AGENDA ITEM 4B

**Planned Unit Development Site Plan
Amendment – Lots 3 and 4 Brook Valley
Corporate Park; 10946 Harry Watanabe
Parkway; JMHJ Properties, LLC**

CITY OF LA VISTA
PLANNING DIVISION
RECOMMENDATION REPORT

CASE NUMBERS: PPUD25-0002;

SITE & LANDSCAPING
PLAN

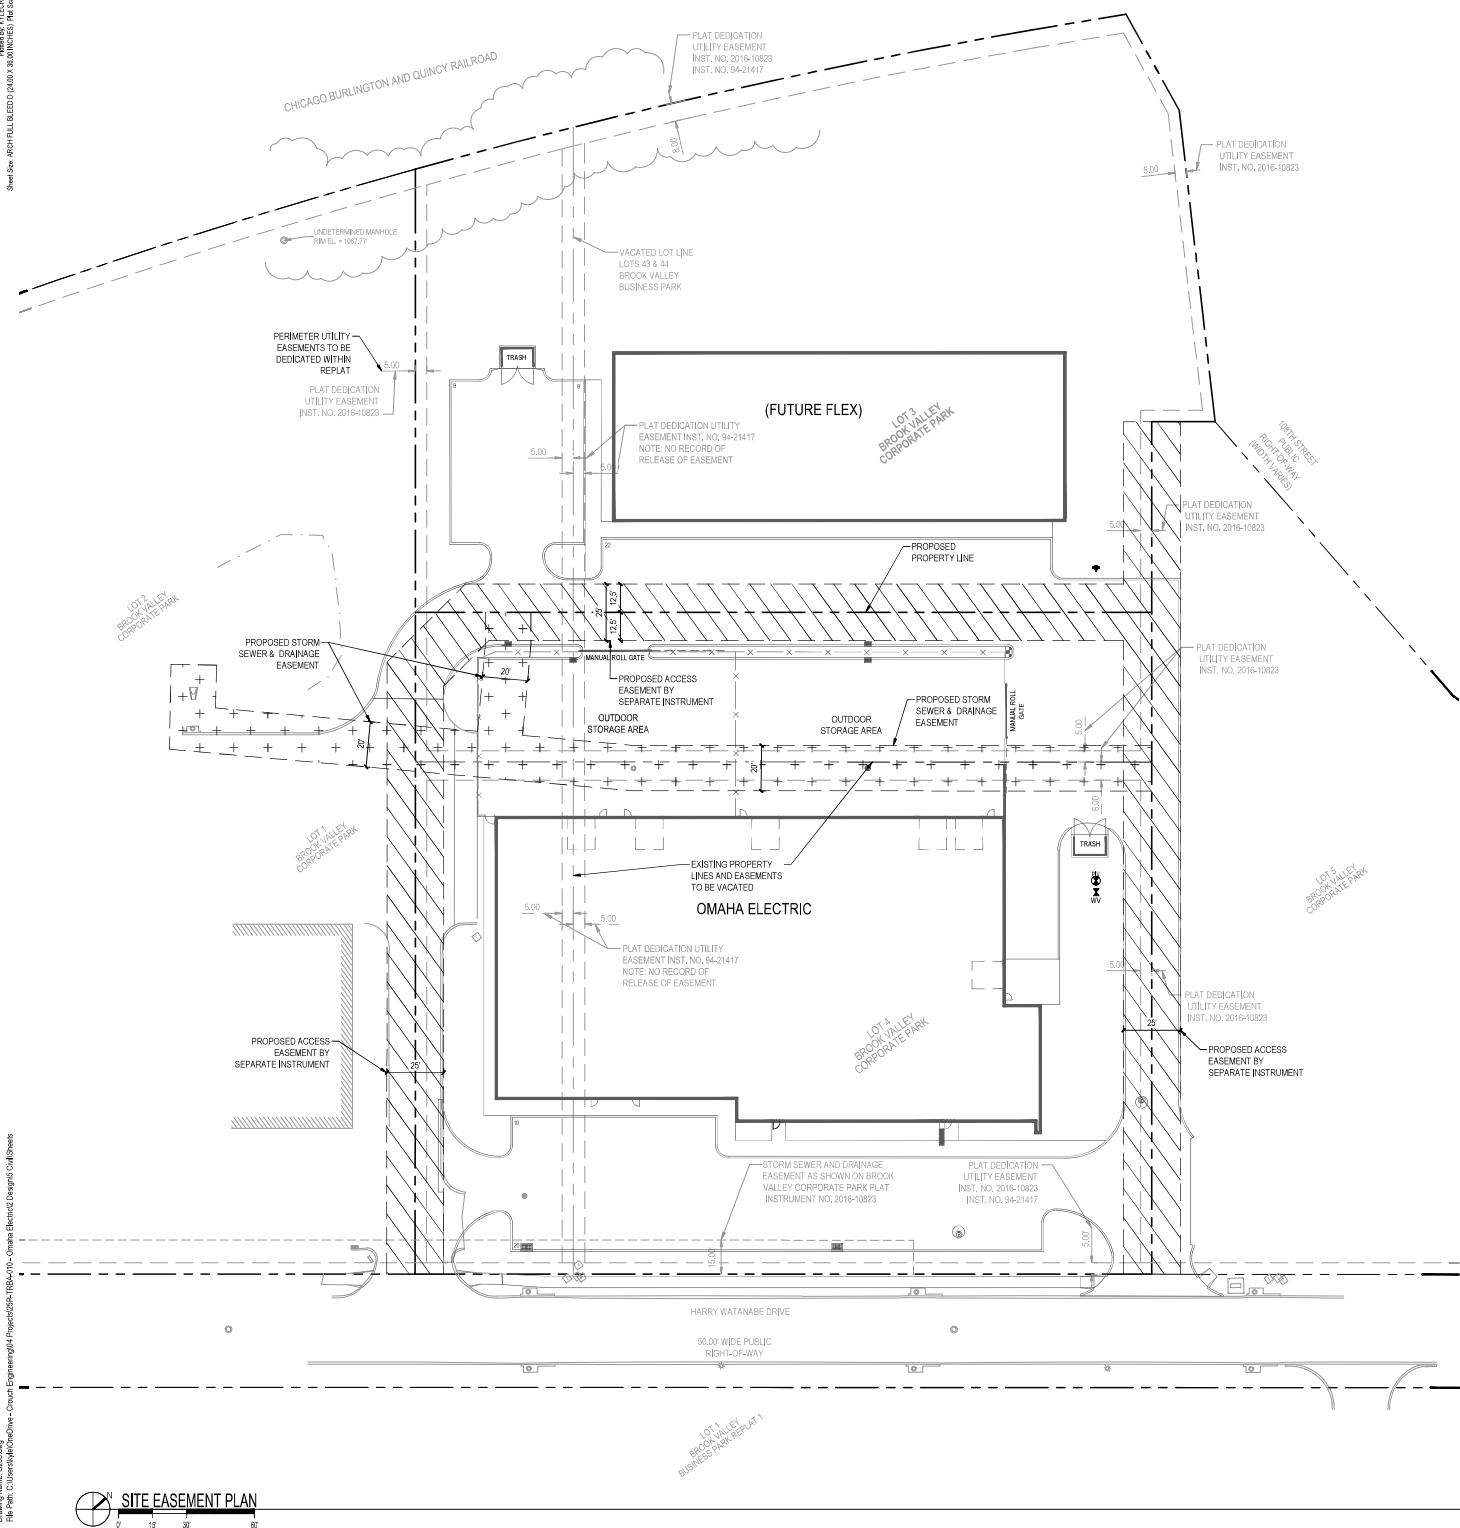
1. Per Section 5.15.04.01, please provide a construction schedule and the anticipated sequence of development for each lot.
2. Pertaining to Section 5.15.04.03, the disposition of stormwater from Lots 3 and 4 will require an easement with the owner of Lot 1. Please submit all applicable easements and covenants with the neighboring property owners.
3. Pertaining to Section 5.15.04.05, please provide locations of fire hydrants that will service Lot 3.
4. Per Section 5.15.05.03.06, please confirm that the proposed parking counts meet the minimum off-street parking requirements of the City of La Vista. This includes the minimum requirements for ADA stalls by type.

The minimum parking requirements per Section 7.06 of the La Vista Zoning Ordinance are 1 stall per 200 square feet of gross floor area for office, and 1 stall per 3,000 square feet for general industrial, as opposed to the 1 per 300 for office and 1 per 5,000 for industrial as referenced on the site plan that you provided. Please also show the dimensions for the ADA parking stalls.

7. Per Section 7.17.03.02, the required landscape buffer along street frontage shall be 15'. It appears that the parking stalls intrude on this 15' landscape buffer along the southern property line of Lot 4 Brook Valley Corporate Park. Per Section 7.17.03.06, this 15' buffer can be reduced to 10' if an equal amount of square feet of landscaped area is provided elsewhere. If you wish to provide this additional landscaped area elsewhere, please identify this location and provide the calculation.

8. In the table on the site plan you identify the correct side yard setbacks for the I-2 district at 30', but in the site plan you have them marked as 20'. Please update these side yard setbacks on the site plan.

9. Per Section 7.17.03.08, the minimum size of an installed deciduous tree shall have a minimum caliper of 1.5", and an evergreen (conifer) tree shall have a minimum height of 5'. Please update the specifications for size on the landscaping plan.

10. All dumpsters are required to be placed within an enclosure. There do not appear to be any dumpsters or enclosures identified on the site plan. Please identify dumpster location(s).

11. Per Section 5.15.05.02.9 and in conjunction with comment 10 above, please show the location of any required screening for dumpsters, mechanical equipment, etc.

1. Can you please revise the operating statement so that it is specific to only Lot 4 of the proposed development? This will be attached as an exhibit to the Conditional Use Permit for outdoor storage.
2. Please provide details on the screening material to be included in the security fencing. Additionally, please demarcate the area on the site plan where outdoor storage will be placed with shading or hashing with a label.

1. Per Section 5.15.04.01, please provide a construction schedule and the anticipated sequence of development for each lot.
 - a. The construction schedules for each lot have been added to sheet 1 of 5 Site & Landscaping Plan. Please note the future work has been noted as range of year per discussions with the owner, no further information is available at this time.

- a. Parking counts have been updated on sheet 1 of 5 Site & Landscaping Plan per noted above. Please note stalls have been added to the reach of Lot 4 building. Handicap Stalls have been dimensioned and denoted by type on the same plan.

- a. Now shown on sheet 1 of 5 Site & Landscaping Plan is the amount of landscape buffer relocated to the east side of the proposed building.
- 8. In the table on the site plan you identify the correct side yard setbacks for the I-2 district at 30', but in the site plan you have them marked as 20'. Please update these side yard setbacks on the site plan.

- a. The side yard setbacks have been updated on sheet 1 of 5 Site & Landscaping Plan
- 9. Per Section 7.17.03.08, the minimum size of an installed deciduous tree shall have a minimum caliper of 1.5", and an evergreen (conifer) tree shall have a minimum height of 5' Please update the specifications for size on the landscaping plan.

- a. The current information provided is sufficient to the code at 0'-2" for the deciduous trees called out. There are no evergreen trees noted on plans.

- a. Two dumpster locations (1 per lot) have been identified on the updated Site & Landscaping Plan. Enclosure product information is also included.
- 11. Per Section 5.15.05.02.9 and in conjunction with comment 10 above, please show the location of any required screening for dumpsters, mechanical equipment.

- a. All mechanical equipment will be located on the roof.

- a. Product information has been provided and areas demarcated on sheet 1 of 5 Site & Landscaping Plan.
- 3. Per Section 6.05.04, please provide a draft post construction storm water management plan (PCSMP)

Title
SITE EASEMENT PLAN

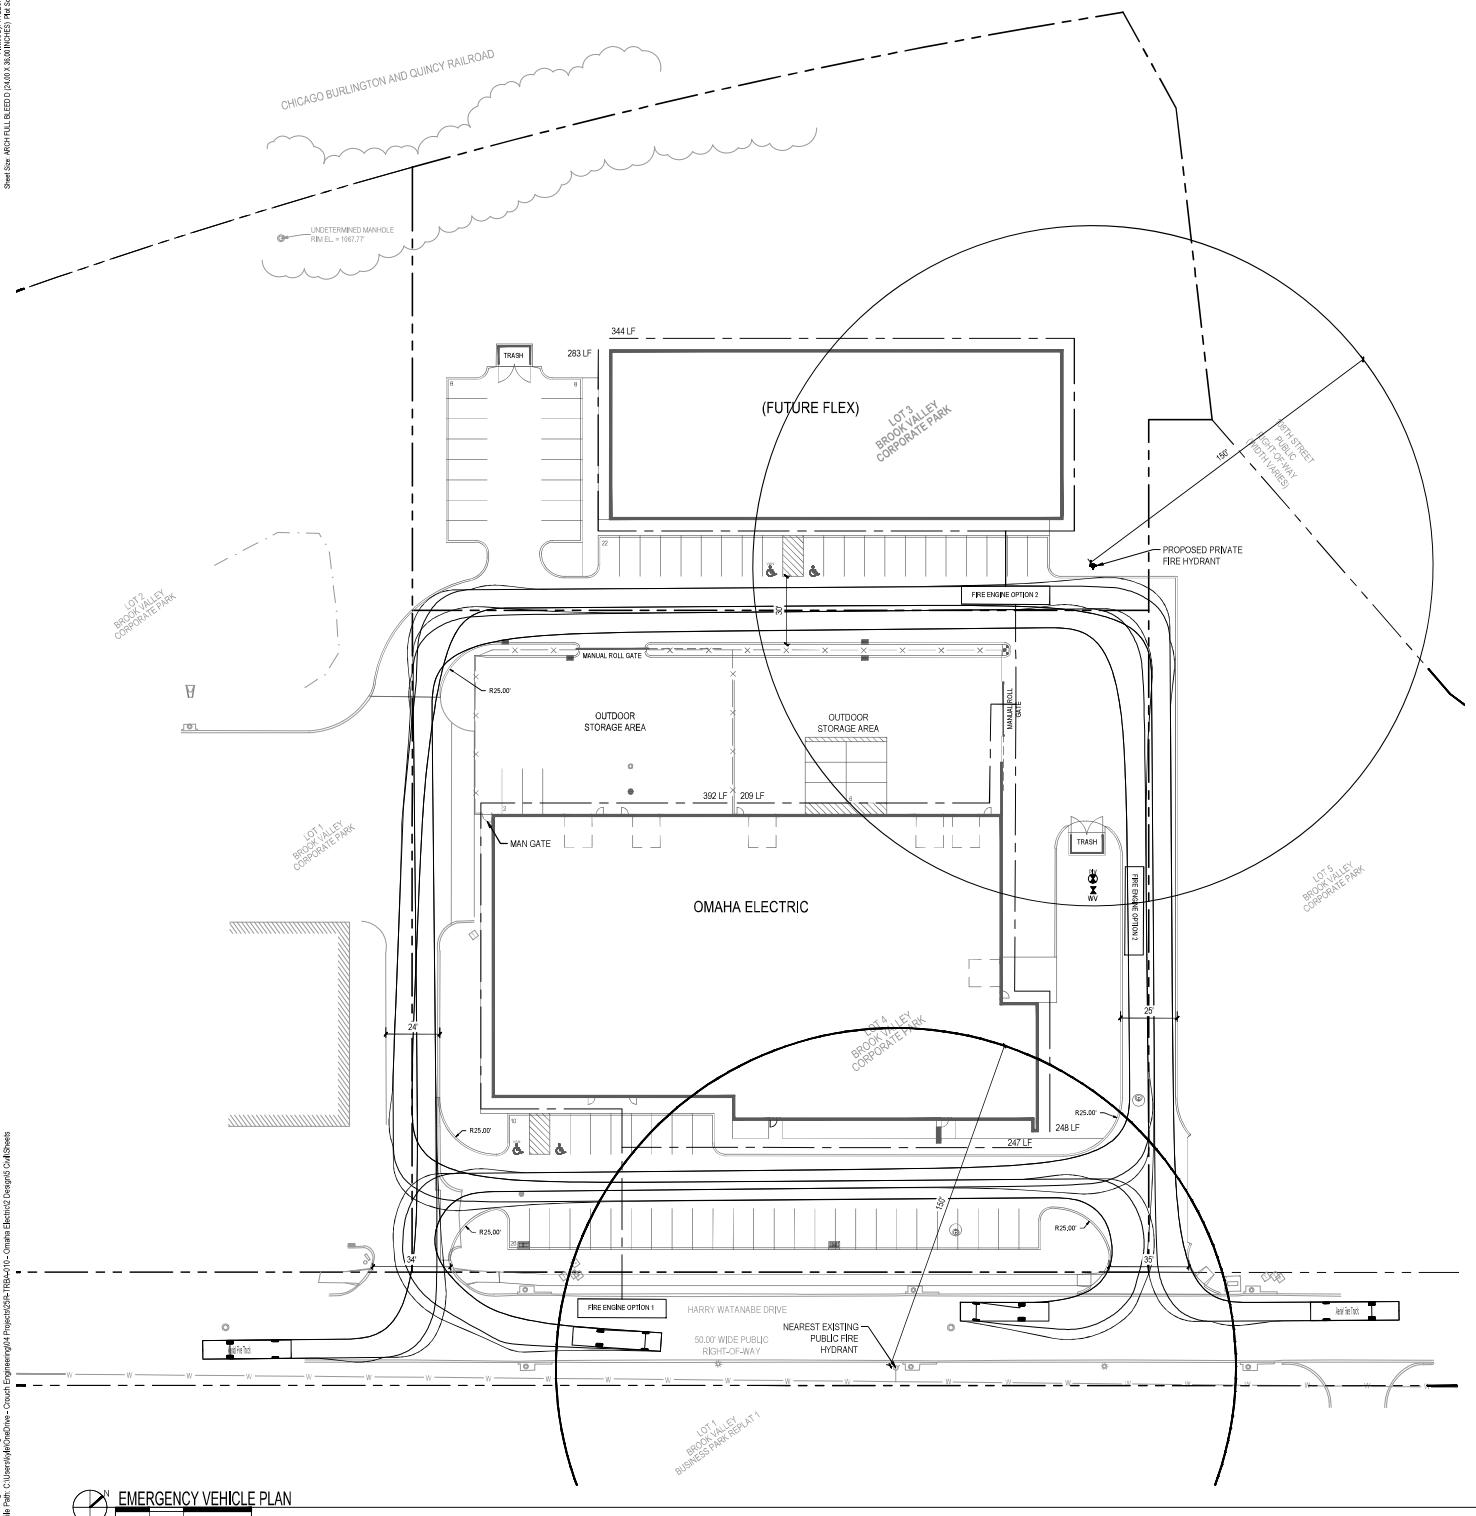
5. Per Section 5.15.05.07, please include a preliminary building rendering with the PUD plan set.
6. Per Section 5.15.05.08, please confirm that all easements and other encumbrances on the site have been delineated on the provided plans.

- a. To our knowledge, the information shown is accurate. Please see added sheet 2 of 5 Site Easement Plan for updated information.
- 7. Per Section 7.17.03.02, the required landscape buffer along street frontage shall be 15'. It appears that the parking stalls intrude on this 15' landscape buffer along the southern property line of Lot 4 Brook Valley Corporate Park. Per Section 7.17.03.06, this 15' buffer can be reduced to 10' if an equal amount of additional landscape area elsewhere. Please identify this location and provide the calculation.

Title
EMERGENCY VEHICLE
PLAN

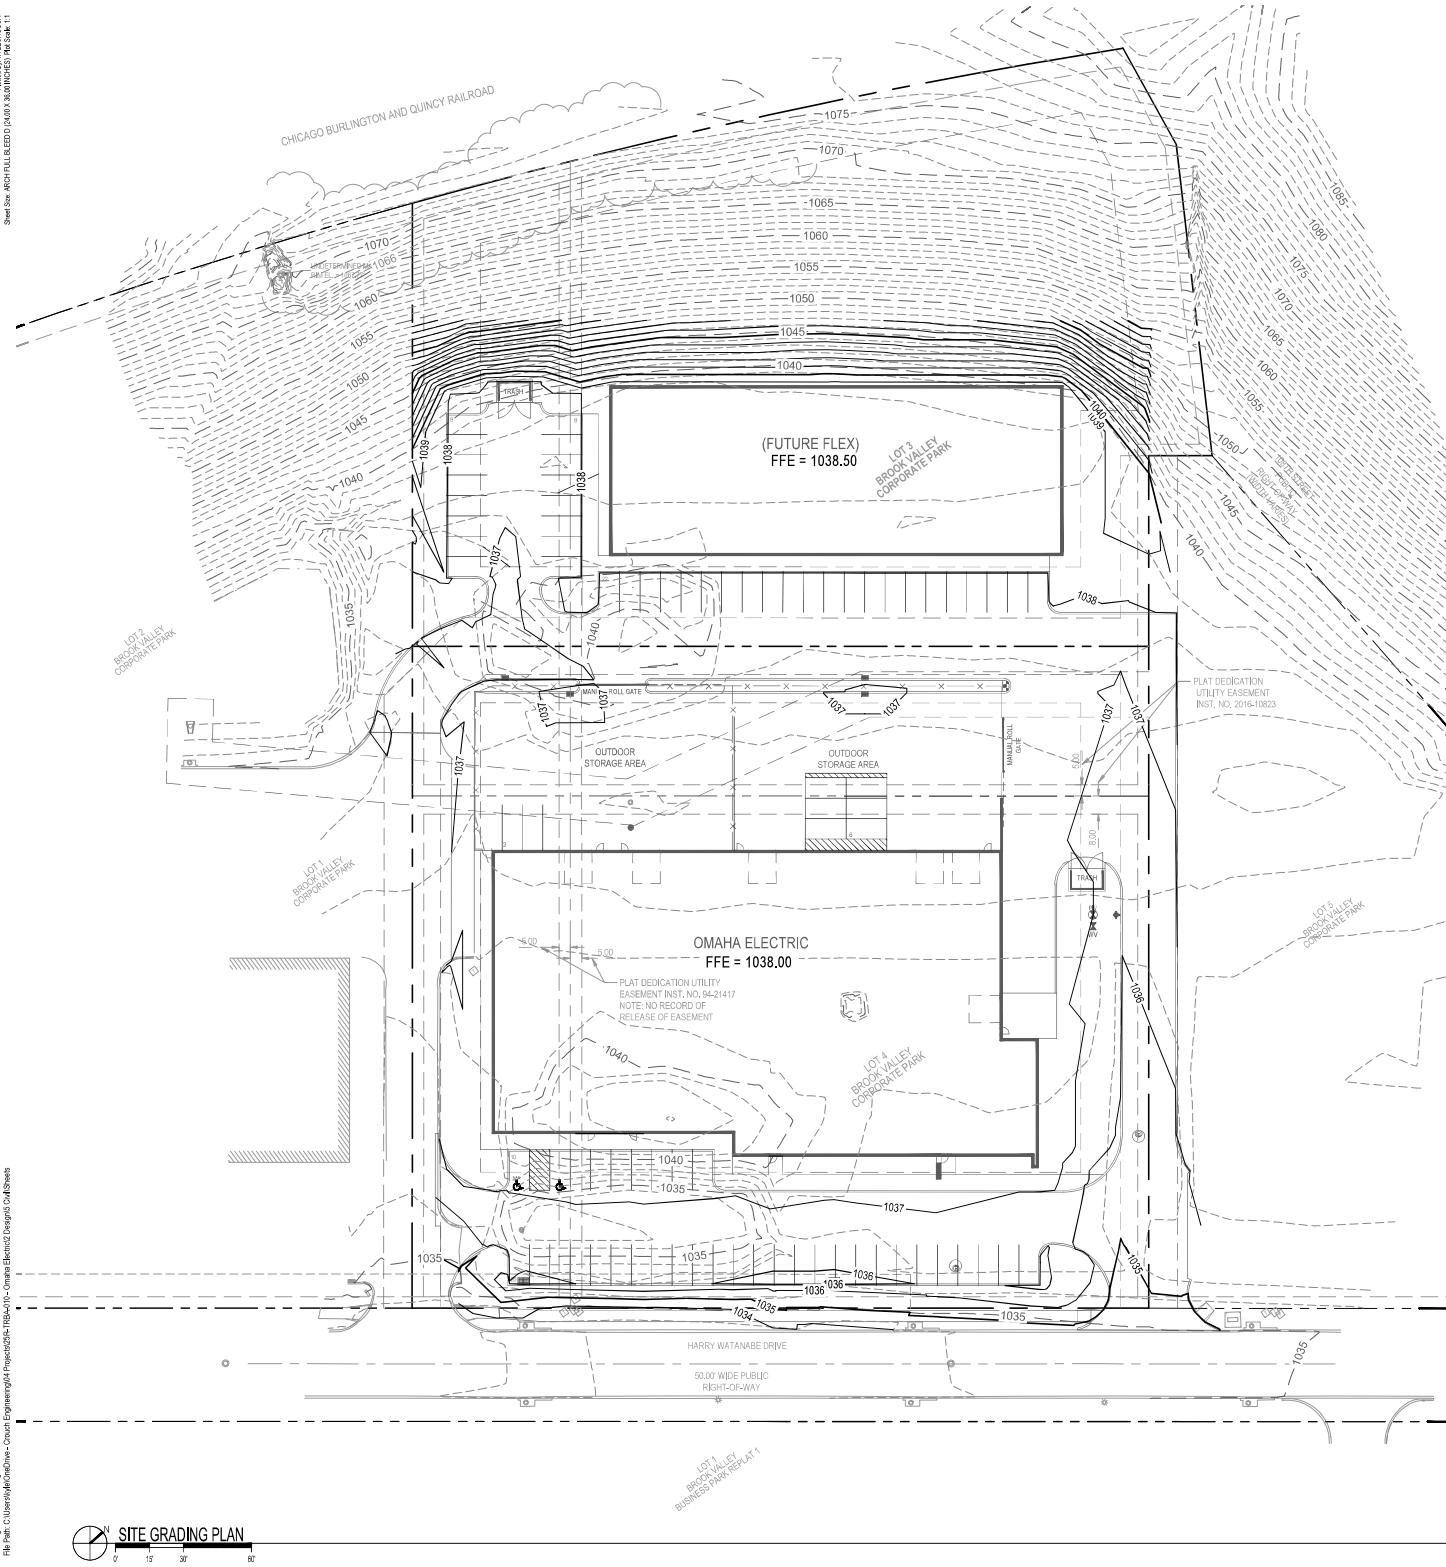
3. Pertaining to Section 5.15.04.05, please provide locations of fire hydrants that will service lot 3.
 - a. This information has been added to sheet 3 of 5 Emergency Vehicle Plan
